ADDENDUM

ADDENDUM NO.: 02

PROJECT NAME: Emiliano Zapata Academy Annex

DATE OF ISSUE: August 23, 2017

DRAWING NO.
A13.1

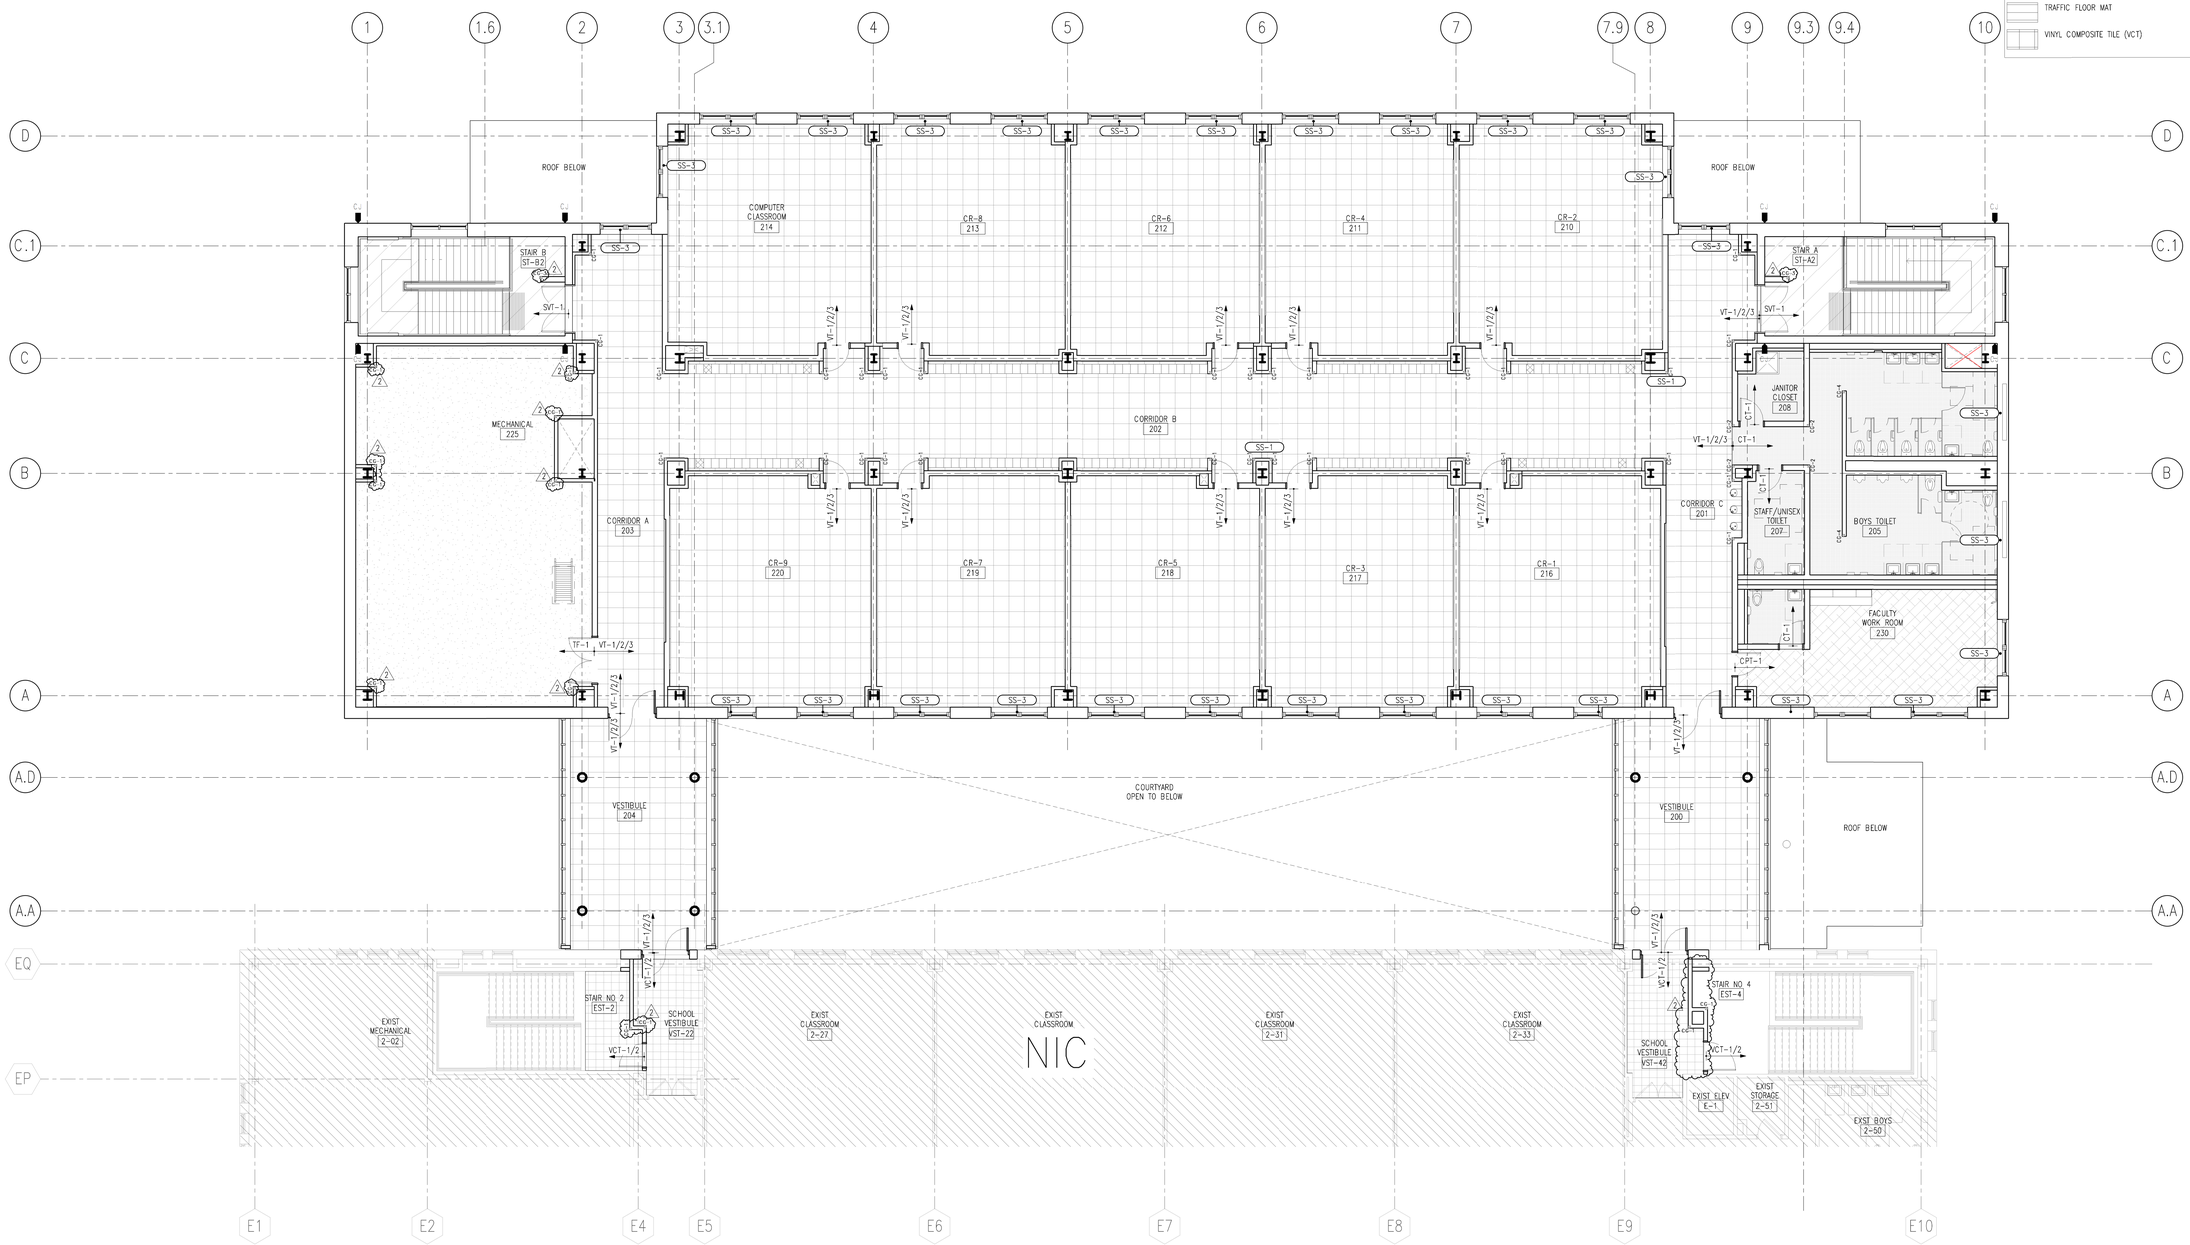
Change 94 SHEET A13.1 Level 01 Finish Plan – REVISED Corner Guard Types

Change 95 SHEET A13.1 Level 01 Finish Plan – REVISED Finish Floor Legend Notes.

Change 96 SHEET A13.1 Level 01 Finish Plan and SHEET A13.2 Level 02 Finish Plan – ADDED Corner Guard Types.

DRAWING NO.
A15.1

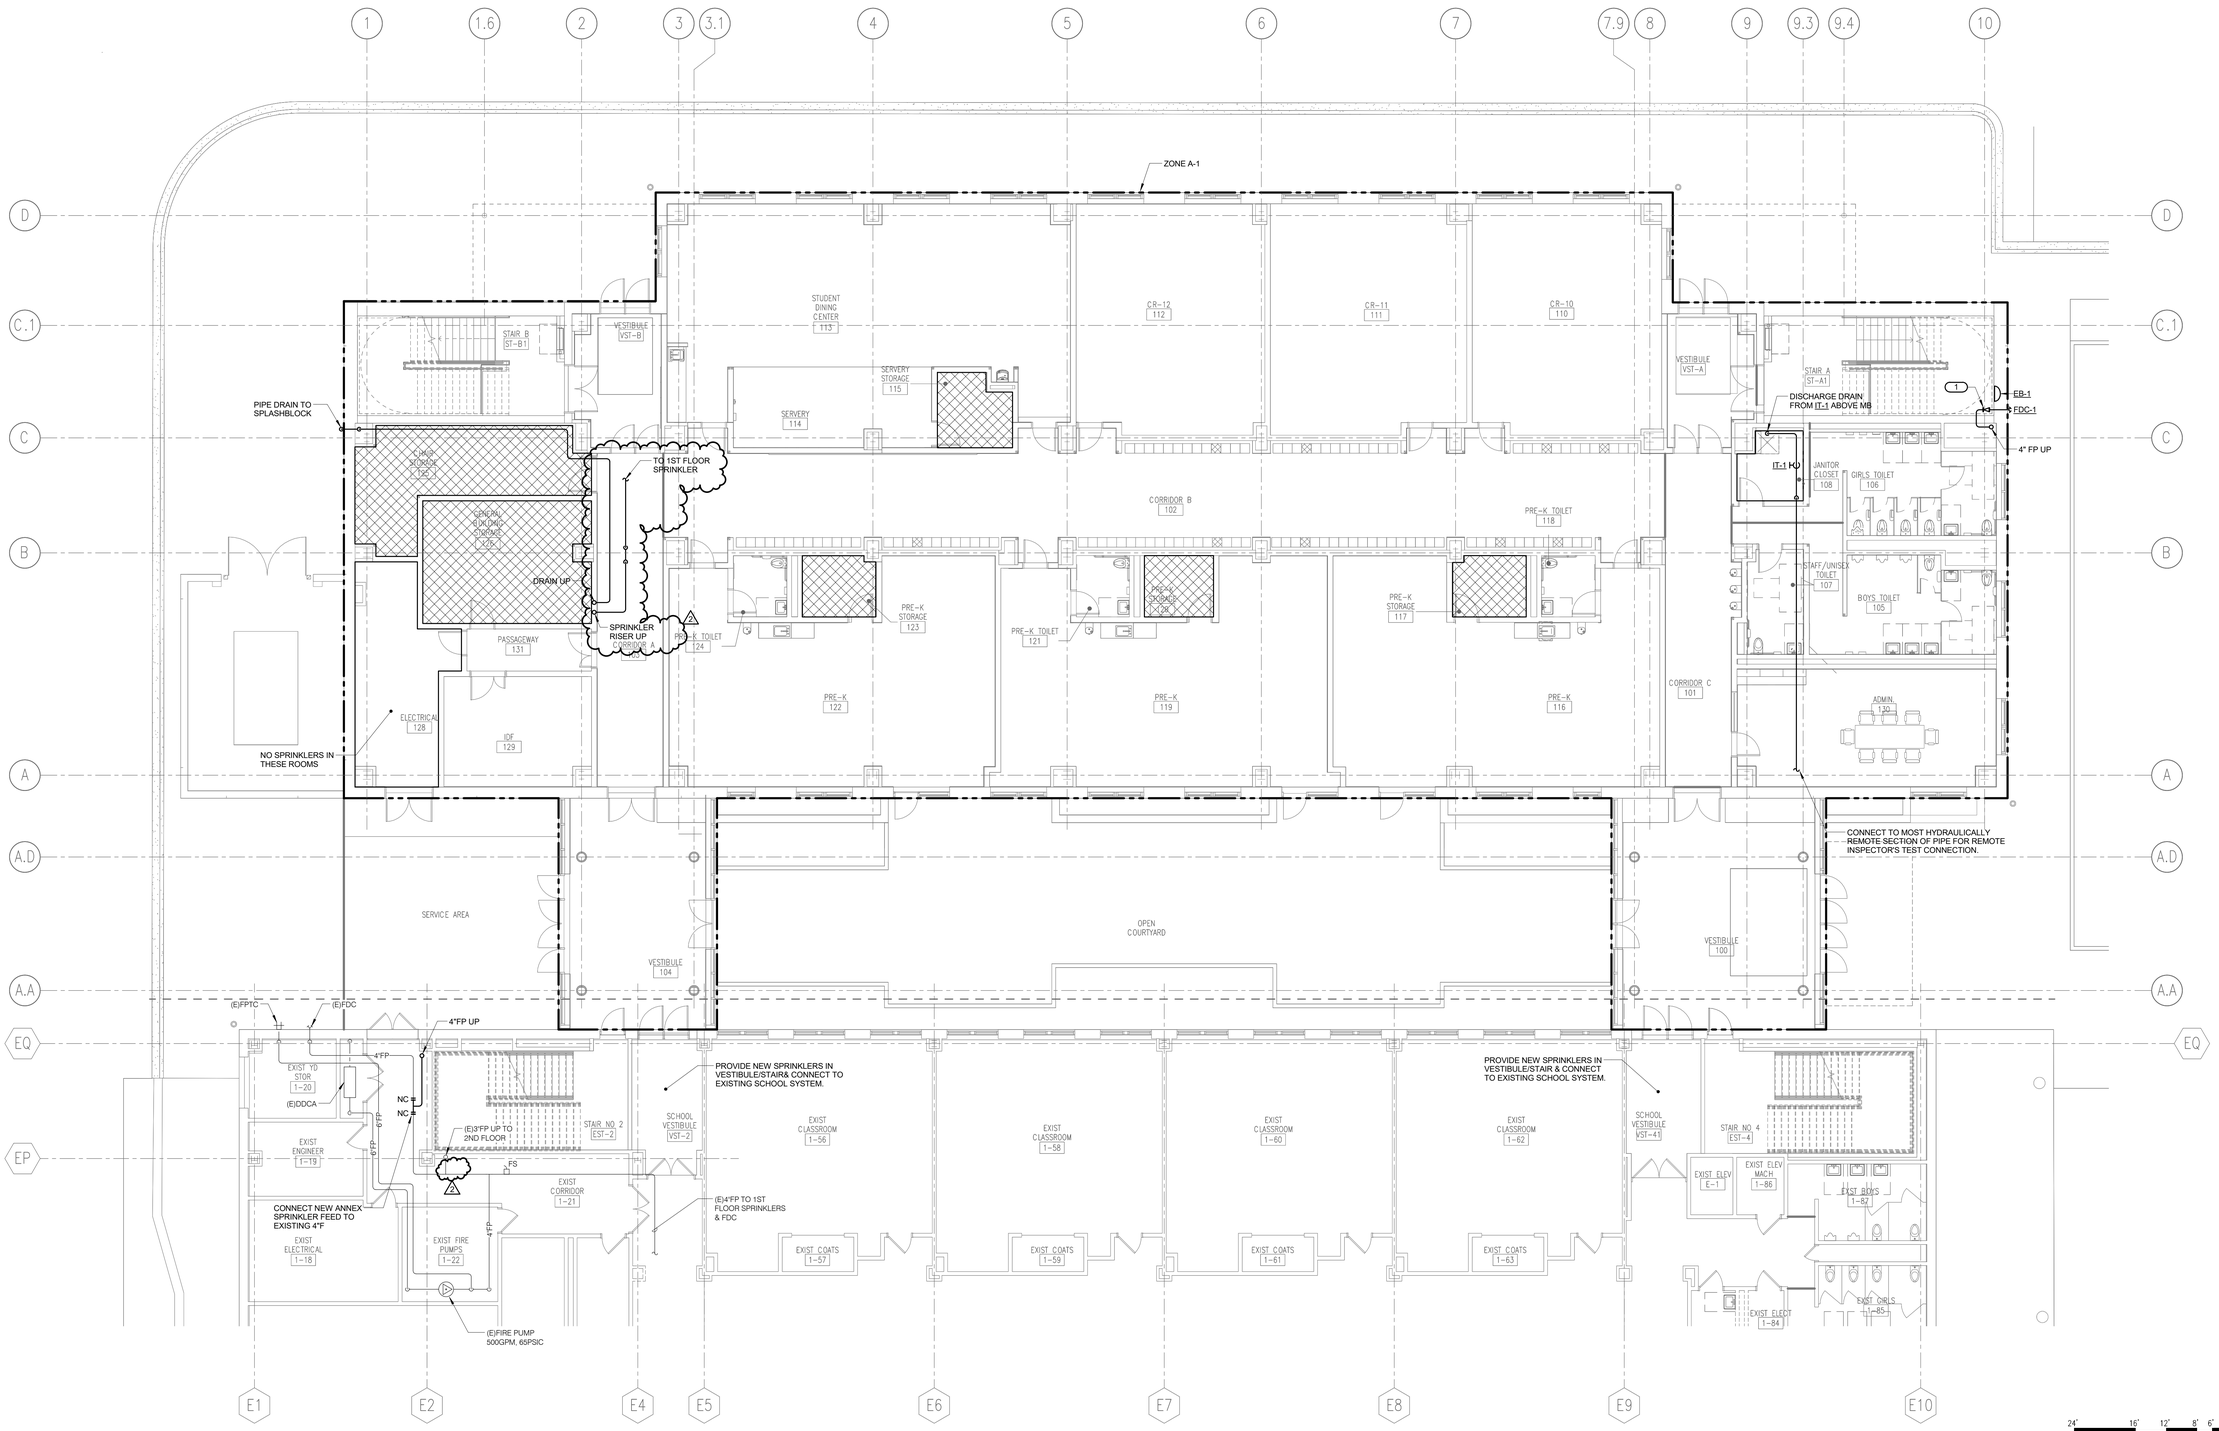
Change 100 SHEET A15.1 Enlarged Toilet Plans – ADDED glass film to interior toilet windows.

DRAWING NO.
F1.2

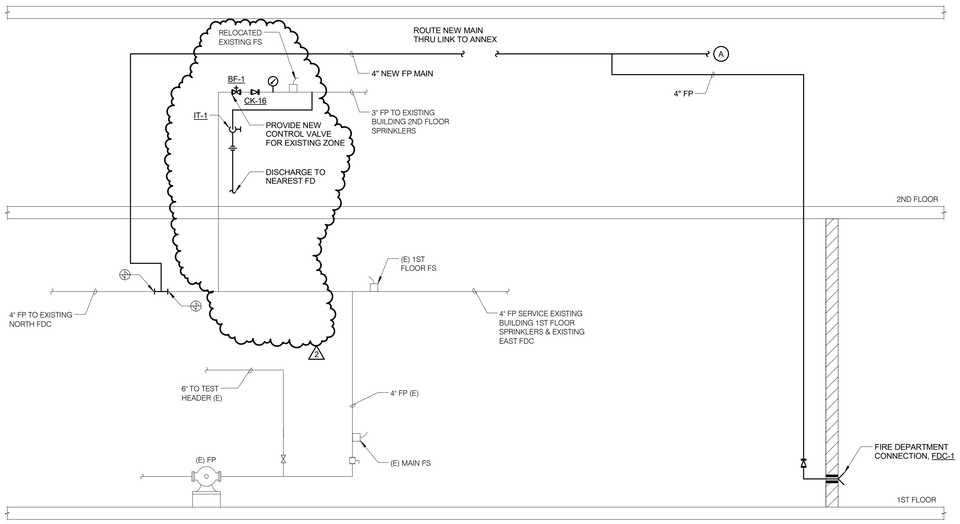
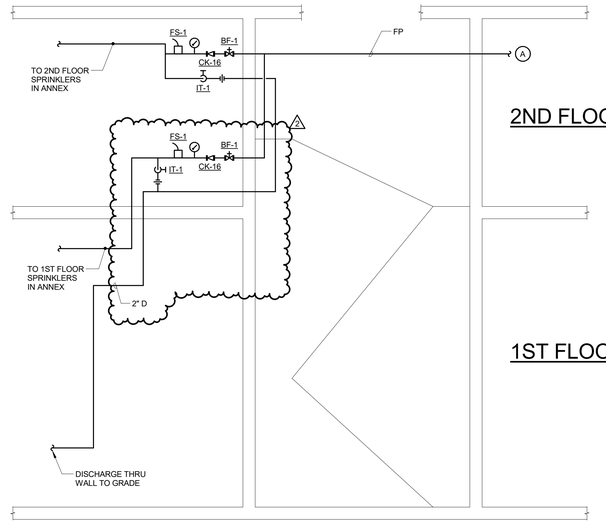
Change 101 SHEET F1.1 Level 01 Floor Plan – Fire Protection and SHEET F1.2 Level 02 Floor Plan – Fire Protection and SHEET F2.1 Riser Diagram – REVISED location of water flow switch and new zone control valve from 1st floor outside pump room into second floor mechanical room on Fire Protection drawings.

Change 102 SHEET F1.1 Level 01 Floor Plan – Fire Protection and SHEET F1.2 Level 02 Floor Plan – Fire Protection and SHEET F2.1 Fire Protection Riser Diagram – REVISED location of sprinkler zone assemblies into second floor mechanical room.
Change 103 SHEET E0.1 Electrical Symbols and Notes – ADDED monitor module symbol
Change 104 SHEET E1.1 Level 01 Floor Plan – Power & Systems – ADDED power for motorized window shades in Lunchroom.
Change 105 SHEET E1.2 Level 02 Floor Plan – Power & Systems – ADDED starter tag/type.
Change 106 SHEET E1.2 Level 02 Floor Plan – Power & Systems – REVISED locations of water flow switches, valve supervisory switches and associated monitor modules.
Change 107 SHEET E1.3 Roof Plan – Power – REVISED disconnect type for CU-1.
Change 108 SHEET E1.3E Existing Building Roof – Electrical Power – REVISED disconnects to show as existing for several fans.
Change 109 SHEET E2.1 Level 01 Floor Plan – Lighting – REVISED exit sign type.

DRAWING NO.
E2.2

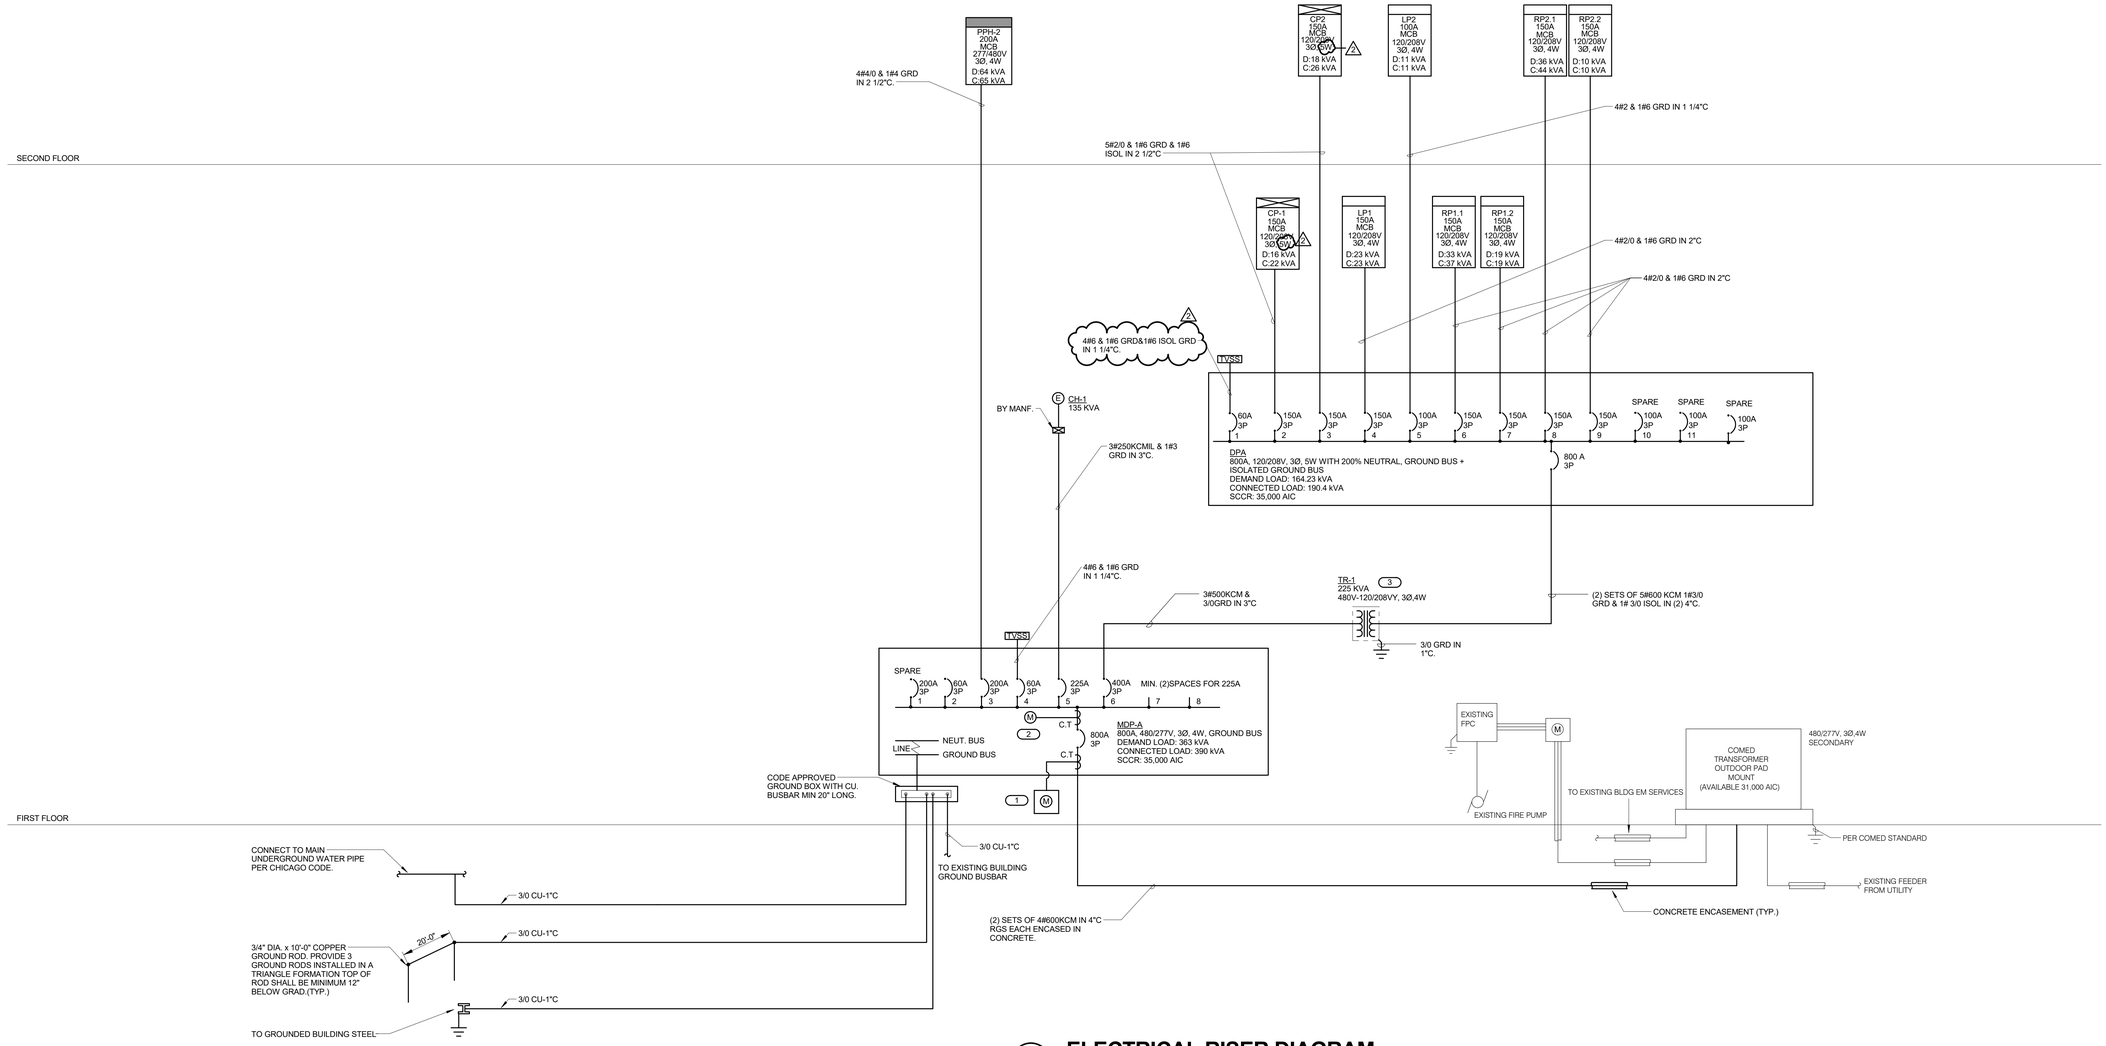
Change 110 SHEET E2.1 Level 01 Floor Plan – Lighting – REVISED vacancy sensor location.
Change 111 SHEET E2.1 Level 01 Floor Plan – Lighting – REVISED exit and lighting fixture locations.
Change 112 SHEET E2.2 Level 02 Floor Plan – Lighting – REVISED emergency lighting and luminaire locations.
Change 113 SHEET E2.2 Level 02 Floor Plan – Lighting – REMOVED one light sensor in Work Room.
Change 114 SHEET E3.1 Electrical Riser Diagram – REVISED wiring for TVSS and CP panel type.
Change 115 SHEET E5.1 Electrical Schedules – ADDED EX3R for outdoor location.
Change 116 SHEET E5.2 Electrical Schedules – REVISED panel RP1.1 to add motorized shades.
Change 117 SHEET E5.3 Electrical Schedules – REVISED Transformer Schedule.
Change 118 SHEET E5.3 Electrical Schedules – REVISED control of VFD-1 and VFD-2 in Variable Frequency Drive Schedule.
Change 119 SHEET E5.3 Electrical Schedules – REVISED Disconnect and Starter Schedule.
